Subject: Duke Energy Corporation
Catawba Nuclear Station Units 1 & 2, Docket Nos. 50-413, 50-414
Additional Information Regarding Mixed Oxide Fuel Lead Assemblies
Assembly Bow (TAC Nos. MB7863, MB7864)

Attachment 1
Response to Request for Additional Information
Treatment of Assembly Bow

Figure 1. Assembly Bow Region Peaking Penalty Factors

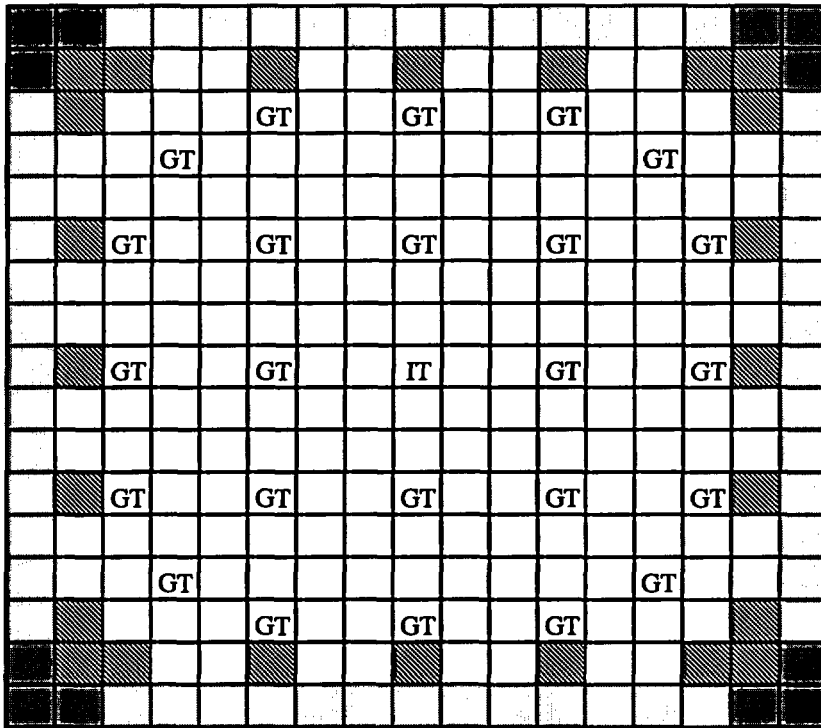
Framatome assembly bow penalty factors have been calculated and supplied to Duke Energy on a fuel pin location specific basis. The bounding factors for the different fuel regions are shown in Figure 1. Duke Energy has reviewed information provided by Framatome as well as the Dominion submittal regarding this issue and has formulated a method of accommodating assembly bow penalties for MOX lead fuel assemblies. The method is outlined below and addresses the matter within the framework of existing Duke Energy methods for reload analysis.

As stated earlier, the fuel assembly bow impact is accommodated by a pin peaking factor penalty distribution within the fuel assembly. The approach taken to evaluate the DNB effects of fuel assembly bow for the MOX lead assembly assessment is very conservative. It involves applying the peaking penalty for assembly bow in a deterministic manner rather than including it as a separate radial uncertainty for inclusion in the Statistical Design Limit (SDL). Since DNB calculations are done on a subchannel basis as per References 5 and 6, the heat input to each channel is strongly influenced by the four surrounding fuel rods. Therefore, the impact of the fuel assembly bow penalty for a particular subchannel will be dependent on location within the fuel assembly. For DNB analyses, the assembly bow peaking penalty will be accounted for by using the radial location dependence of the peaking penalty distribution. The pin-by-pin penalty will be overlaid with the MOX lead assembly peaking distribution in the DNB analyses such that the local effect of assembly bow is applied to the MOX lead assemblies on a pin by pin basis.

If desired, a more simplified and conservative approach of applying a single peaking penalty, equal to the maximum pin penalty of 7.65%, may be applied to the entire assembly for DNB analyses.
